City of Alexandria, Virginia

MEMORANDUM

SUBJECT: 711 PRINCESS STREET, BAR CASE #2011-0073

Docket Item # 3
BAR CASE # 2012-0073

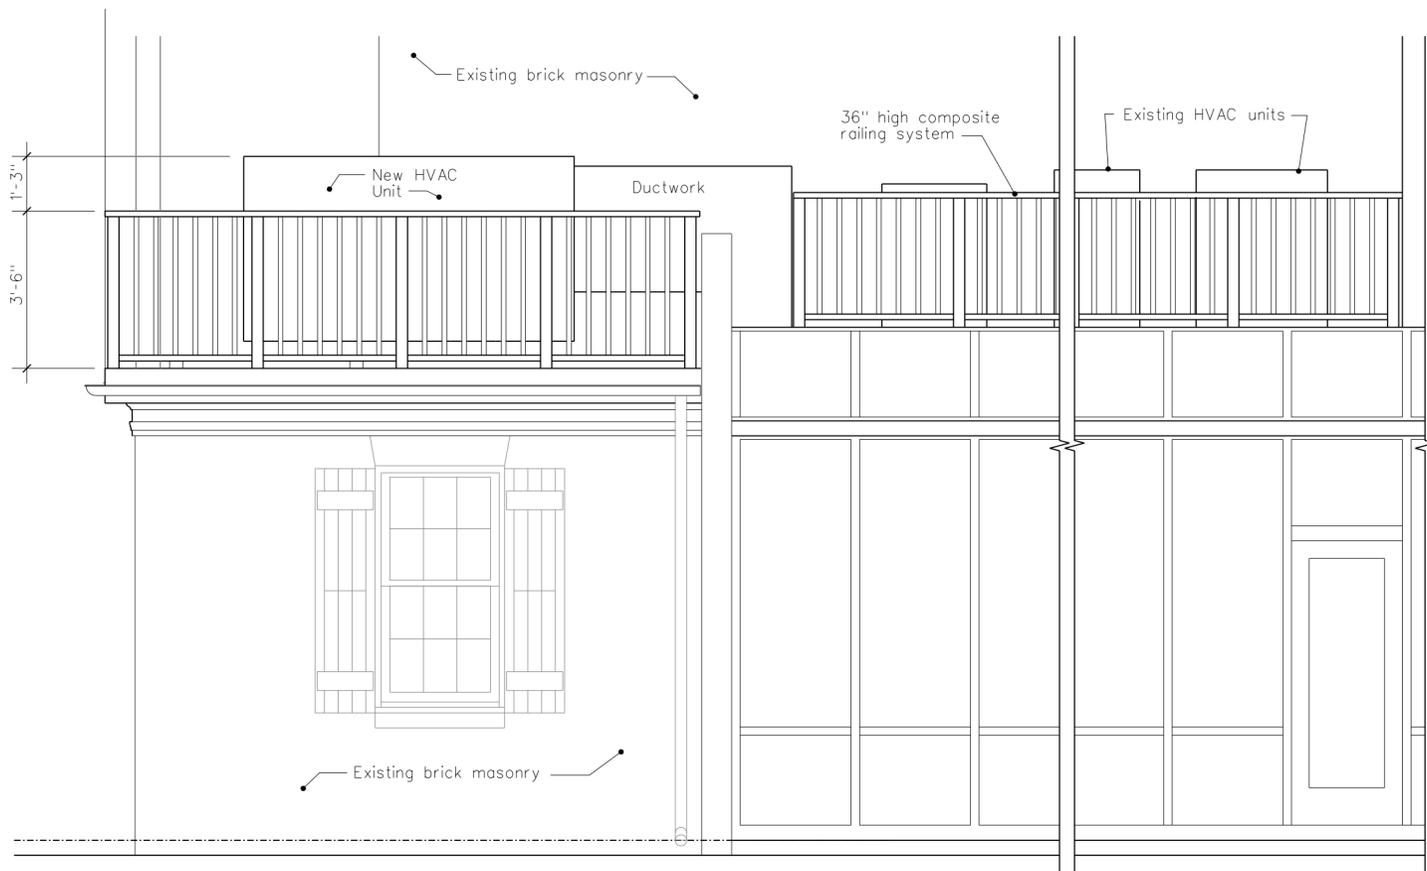
After the Board's deferral, Staff discussed options for screening with the applicant. On the rear of the building adjacent to the package unit is a second-story porch with simple wood balustrade. The applicant has proposed a similar balustrade around the rooftop HVAC units using a composite picket railing. The proposed railing will screen the three existing HVAC units above the greenhouse, as well as the proposed replacement package unit and associated ductwork on the one-story addition.

Staff supports the proposed railing around the rooftop HVAC units and finds that it will effectively screen both the existing and replacement units. As mentioned in the previous report, if this application were for new units, Staff would recommend that they be located on the ground. However, the request is before the BAR is simply to replace an existing package unit and relocation of the associated ductwork on the interior of the building to relocate the package unit would be a significant disruption to the business. Staff, nevertheless, finds the rusted ductwork to be particularly unsightly, as it draws one's attention away from the very handsome historic building, and recommends that it either be painted or replaced as part of the project. Staff believes that painting all the units and ductwork to match the adjacent wall and installing a simple balustrade immediately in front of the units will serve as effective screening and unify this jumble of mechanical equipment while still allowing the necessary air circulation.

STAFF RECOMMENDATION, MAY 16, 2012: Staff recommends approval of the application with the condition that the new unit and associated ductwork be painted to match the adjacent wall surface and that the proposed composite railing be paintable, millable and solid-through-the core.

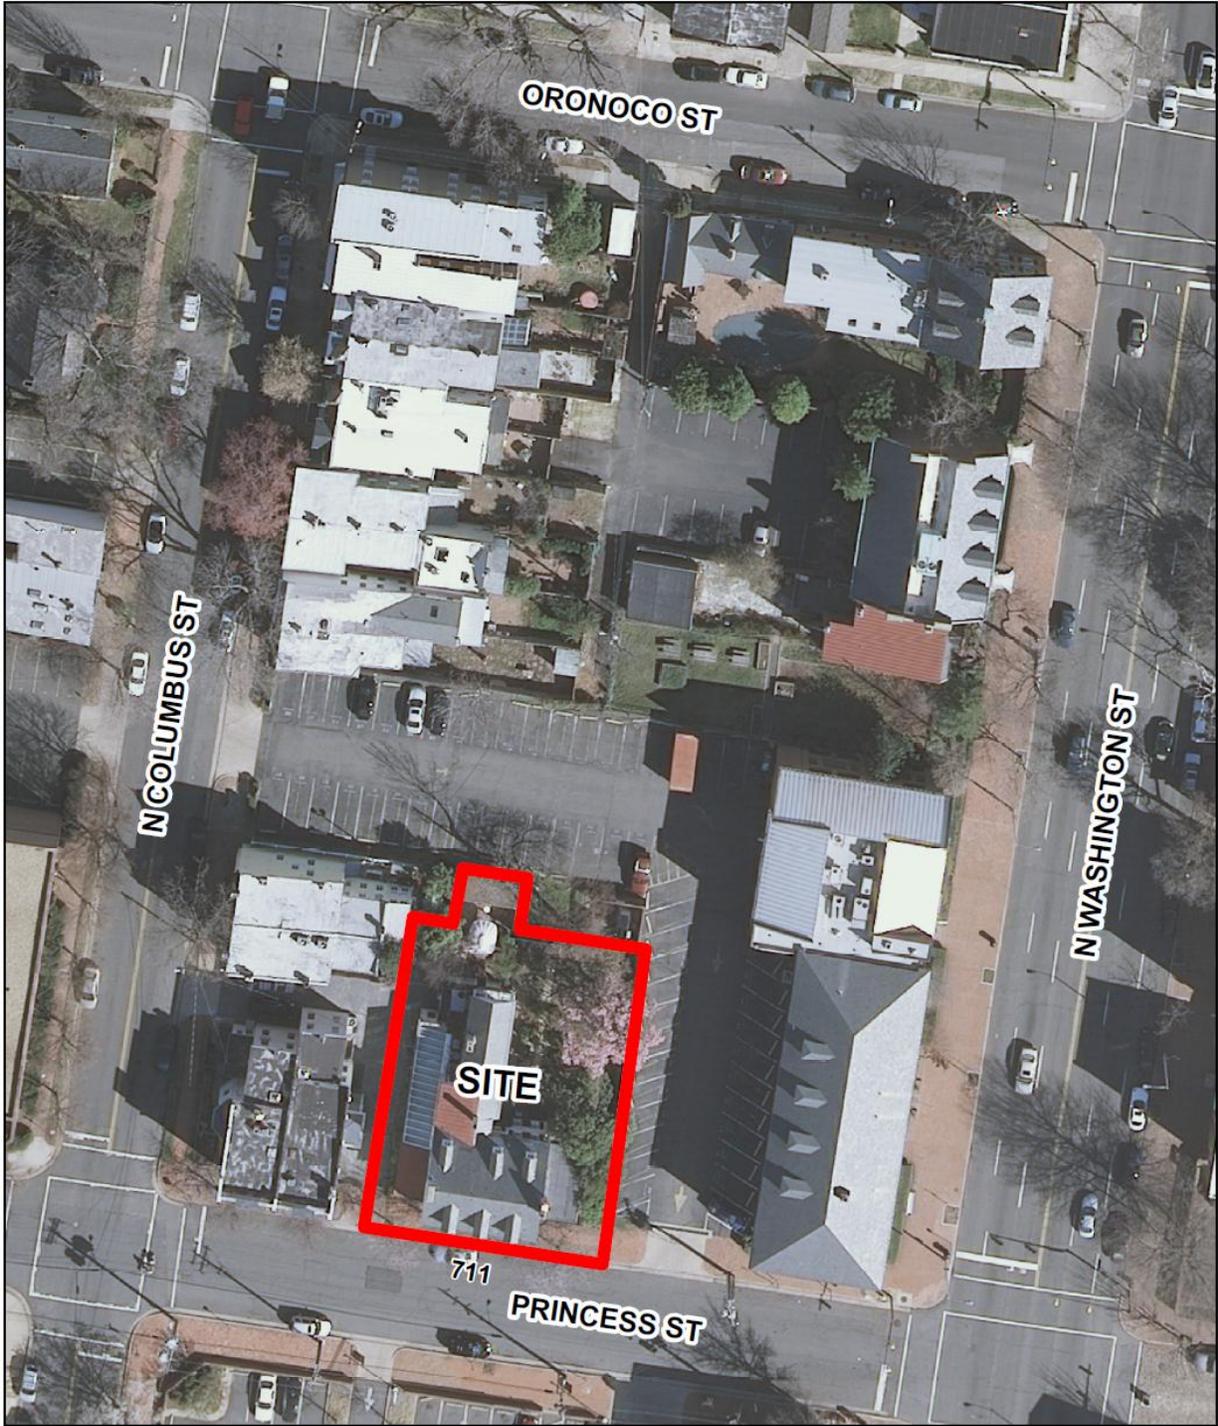
Mr. Smeallie stated that the existing condition of the rusty ductwork for the rooftop HVAC was awful and that this was an opportunity to explore other options, possibly to move the units to the ground. He requested more information on the screening material and design.

Mr. Neale noted that the units will require sufficient clearance in considering the location of the screening. He agreed that it was unsightly and requested that the proposed screening return to the Board.

The Board found the existing rooftop equipment to be unsightly and noted that this was a very important freestanding early 19th-century building.

STAFF RECOMMENDATION, April 18, 2012: Staff recommends denial of the waiver of rooftop screening and approval to replace the HVAC package unit with the condition that the new unit and associated ductwork, as well as the existing HVAC condenser units, be painted to match the adjacent wall and that a simple metal railing be installed to serve as screening, with final approval by Staff.

Figure 1. Plat of subject property showing location of HVAC units.

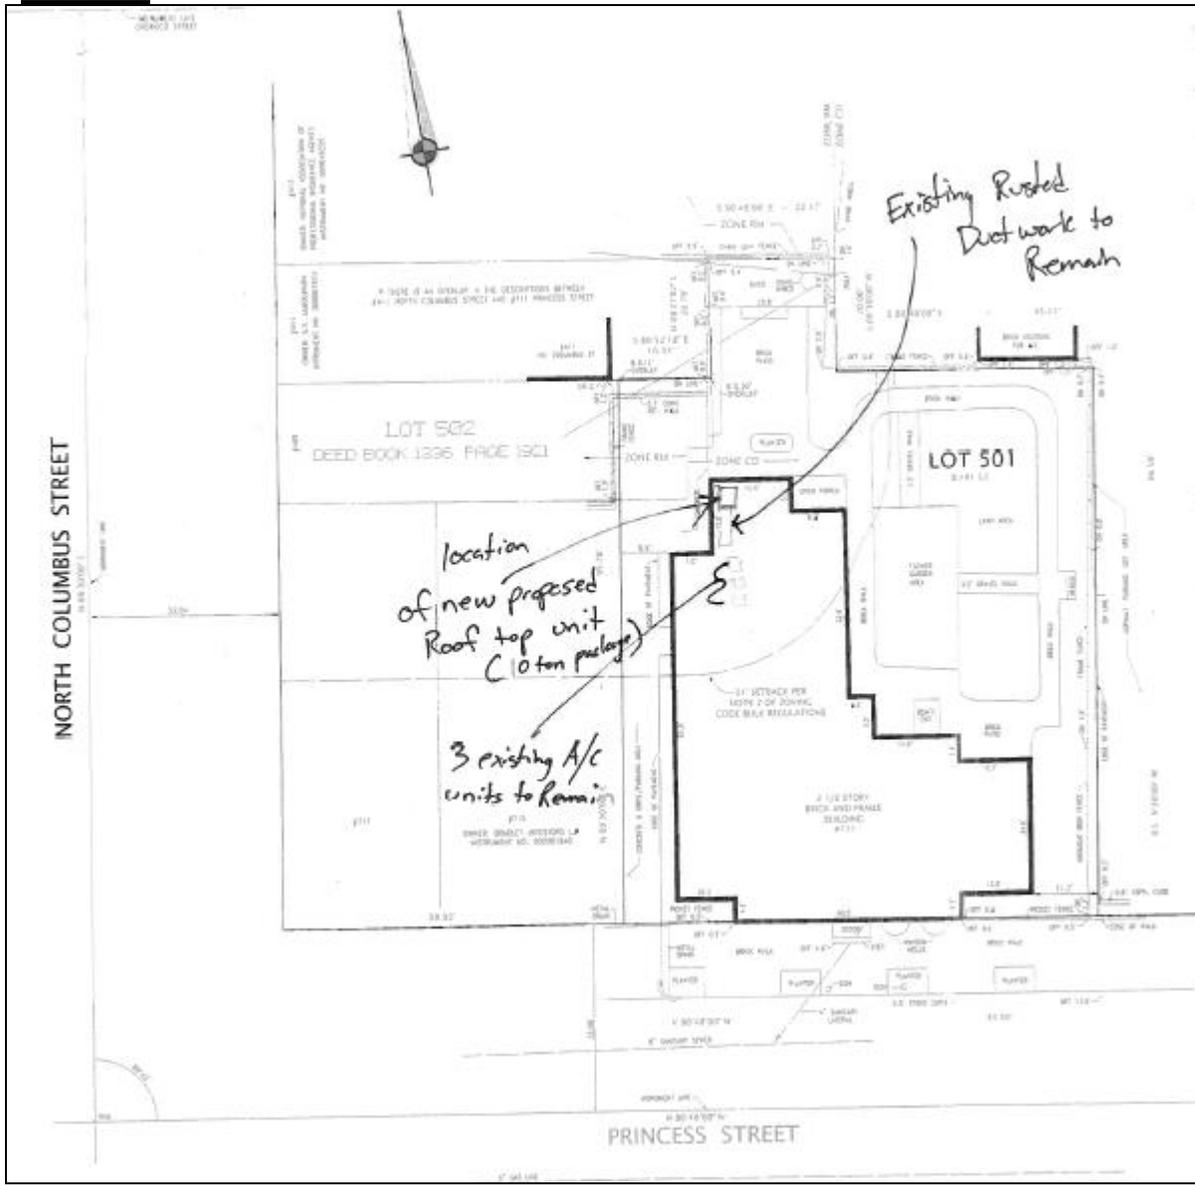
The applicant is requesting approval to install rooftop HVAC equipment on a one-story rear addition and a waiver of the rooftop HVAC screening requirement. The proposed unit replaces a package unit with sizeable exterior ductwork connecting to interior ductwork. The existing rusting ductwork will remain. The replacement unit will measure approximately 5.25 feet in depth, 9.6 feet in width and 2.5 feet in height, similar in size to the existing unit. The unit is plainly visible from both Princess and North Columbus streets.

Following archival research for this application, and discussion with the property owner, it is apparent that it is unlikely that the existing package unit was ever approved by the Board. The existing unit will be replaced in the same location as the existing and is located above a one-story element toward the rear of the west side. There are also several split system HVAC condenser units located on the same rooftop which are also visible. The property on which the house is located is relatively large and there are potential areas where units could be ground-mounted. However, moving the package unit and duct work as well as multiple HVAC

Staff recommends denial of the waiver of rooftop screening and approval to replace the package unit with the condition that the new unit and associated ductwork, as well as the existing HVAC condenser units, be painted to match the adjacent wall and that a simple metal railing be installed on the rooftop to serve as screening, with final approval by Staff.
